**King's Mark
Environmental
Review
Team
Report**

EMERY PARK

KENT, CONNECTICUT

Environmental Review Team Report

Figure 2

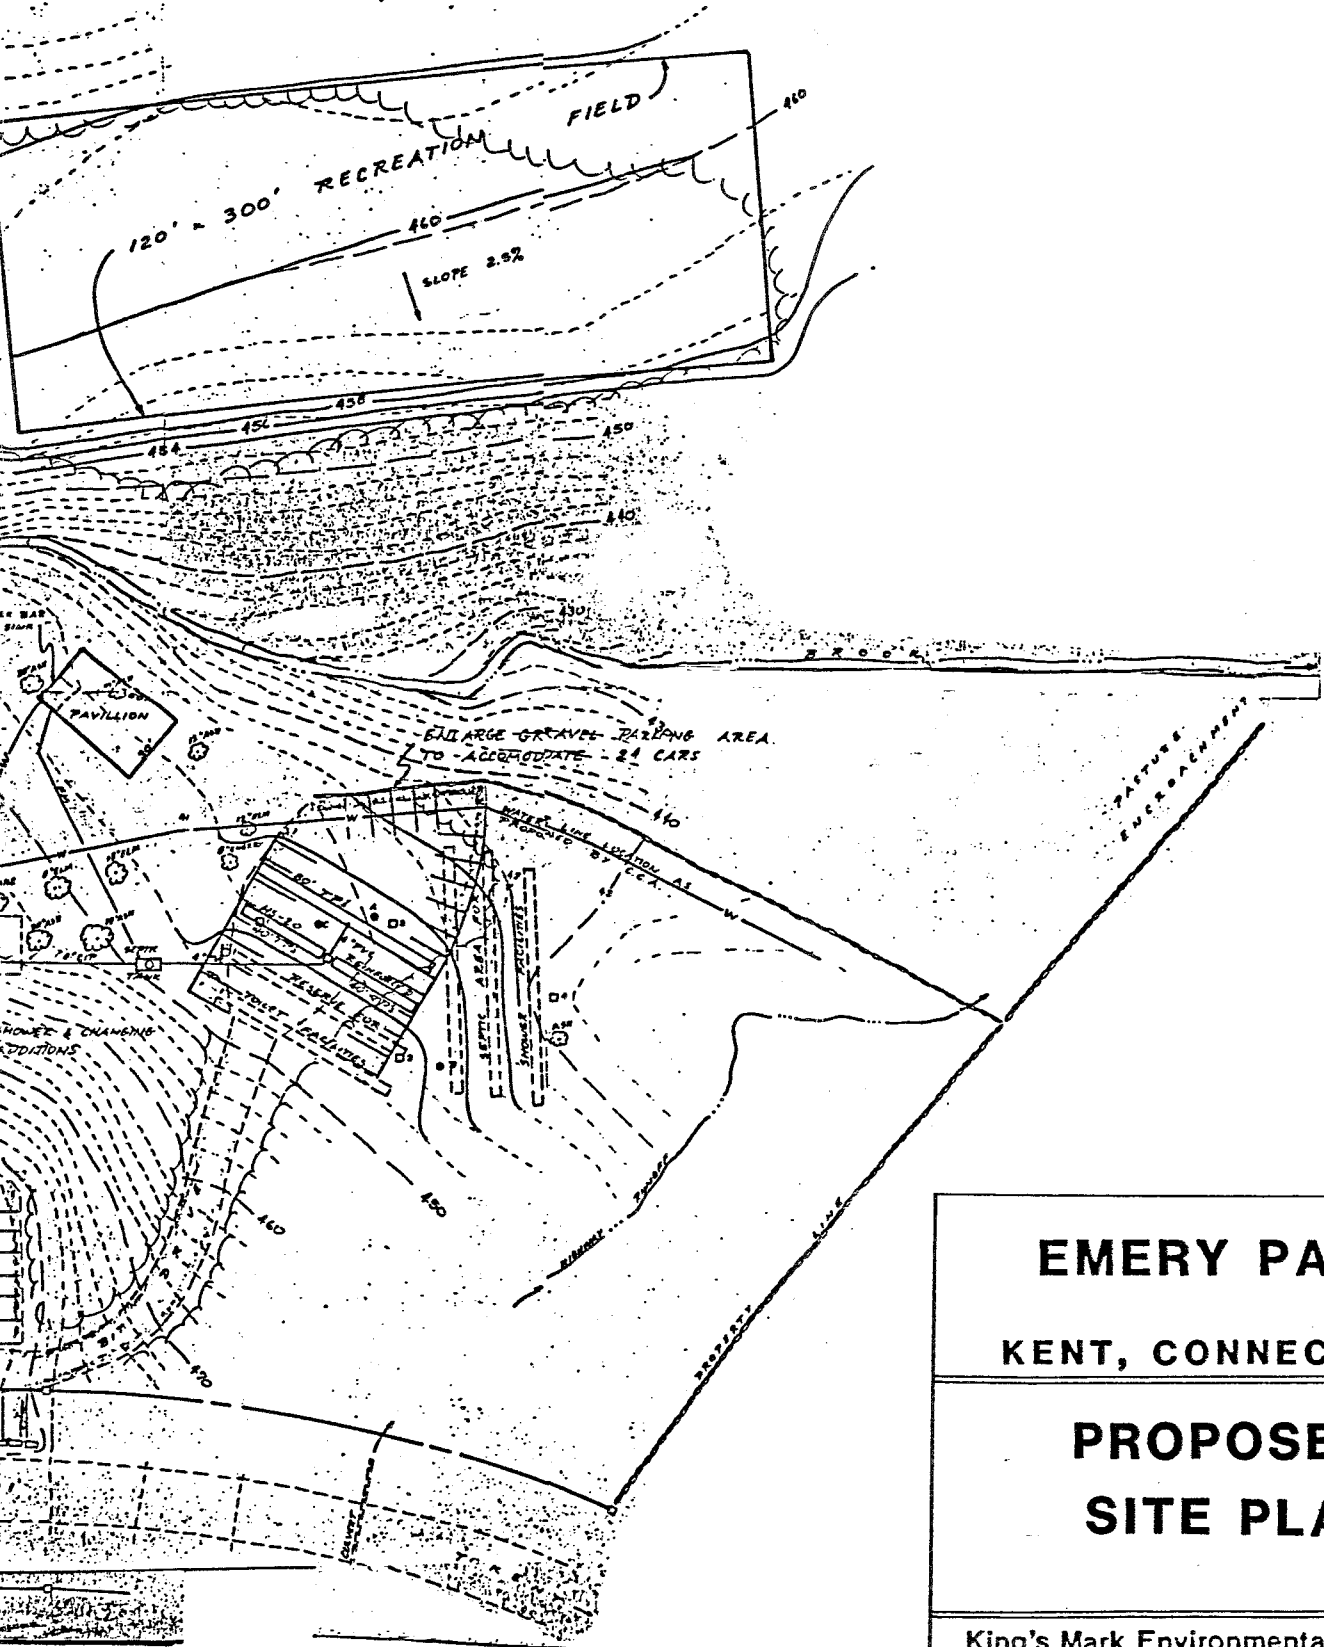
The current proposals for Emery Park show 3 to 4 crossings over the stream: 1 for cars and up to 3 for foot traffic. This number of crossings could cause an excessive negative impact on the stream. Each permanent crossing would involve bank disturbance, filling and stream constriction. Having 1 major crossing for logging trucks, service vehicles and foot traffic, with a seasonal crossing at a second location, would cause less damage to the stream corridor. Erosion and sediment controls should be used during all construction activities adjacent to the stream or wetlands. No fill material should be placed in the stream or wetland areas.

Carroccio-Covill & Assoc., Inc. proposal to drain and fill the wetland northeast of the two ponds in Emery is potentially detrimental to water quality in the park itself and to downstream surface and groundwater. Because this is a GA groundwater area and the municipal wells are less than 1/2 mile downstream, any action taken at this site should be carefully reviewed for its impact on water quality. The wetland is acting as a filter to clarify runoff from the very steep watershed and serves a critical function.

Comments about some of the other proposals for Emery Park, considering their impacts on water quality, include:

- 1) The snack bar sink is 4 feet below the septic tank level. The septage would need to be pumped to tank. It might be better to raise the location of the snack bar to allow gravity flow.
- 2) Leach field as shown in Carroccio-Covill and Assoc., Inc. 1983 plan will need to be carefully planned. Flooding by runoff from the very steep driveway could cause flushing of septic field directly into brook.
- 3) Winter use of lower parking lot would necessitate use of much salt and sand on the steep driveway. The runoff of these materials over the frozen ground and into the brook needs to be prevented. Winter parking at road level only might be a better option.
